World Forum for Harmonization of Vehicle Regulations

Working Party on Automated/Autonomous and Connected Vehicles^{*}

Automatically Commanded Steering Function

Proposal for amendments to UN Regulation No. 79 (Steering equipment)

Figure 1
Lateral Acceleration Filtering: Comparison of tests led on 4 vehicles in the same curve

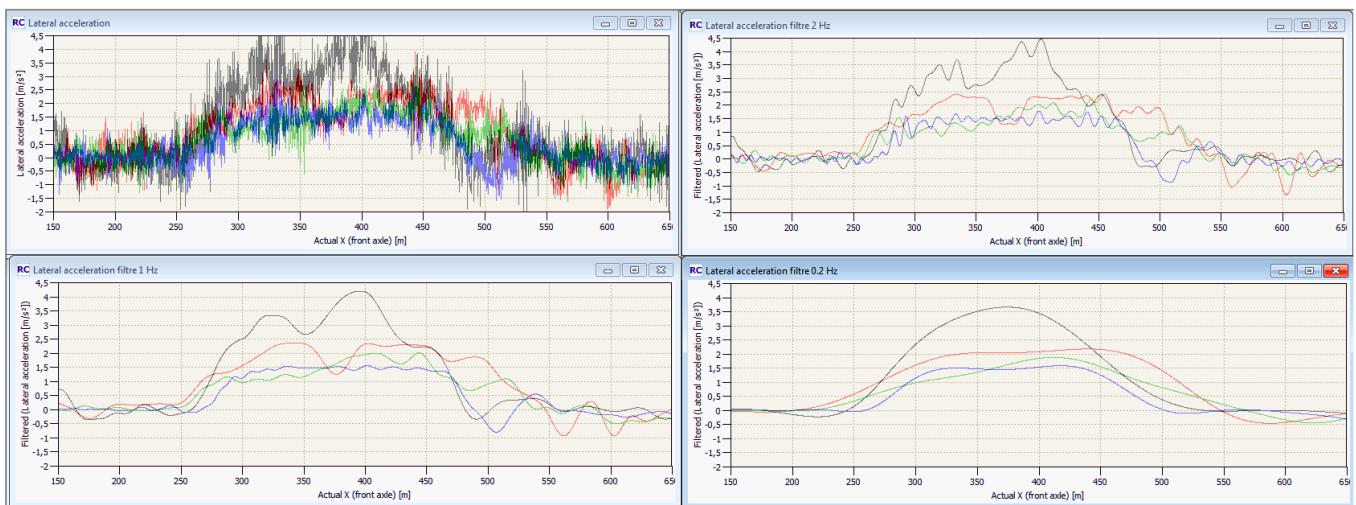
1. For keeping a traceability, it could be interesting to indicate in the report both the position at which the lateral acceleration was measured and the position of the centre of gravity of the vehicle.
2. For dynamical tests the usual value of sampling rate is at least 100 Hz.
3. The figures below show the shapes of the lateral acceleration signals versus the value of the cut-off frequency: No filter, filter at 2Hz, filter at 1 Hz and filter at 0.2 Hz.
4. The results show that the best representation of the dynamical behavior is obtained when the used filter is 1Hz.

- Quadrant 1 shows the raw data (no filtered)
- Quadrant 2 shows the signal filtered at 2Hz
- Quadrant 3 shows the signal filtered at 1Hz
- Quadrant 4 shows the signal filtered at 0.2hz.

To determine the lateral acceleration, the raw data shall be filtered by applying a fourth order Butterworth filter with a cut-off frequency of 1Hz.

Lateral Acceleration Filtering: Comparison between the 2 proposals for a vehicle near the limits

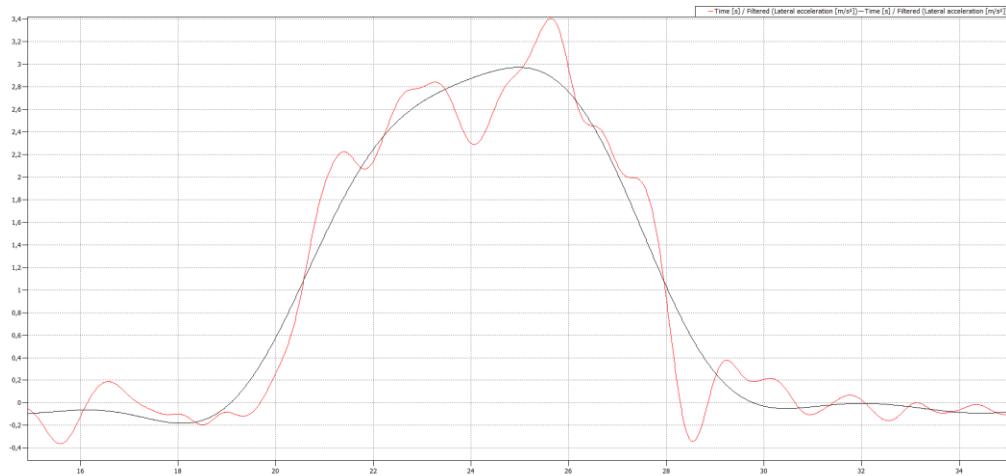
Blue line (0.2hz) and red line (1 Hz) as proposed in this document. In the first case the vehicle passes the test (Maximum value: 3 m/s²) while in the second case the vehicle fails the test (maximum value: 3.4m/s²).
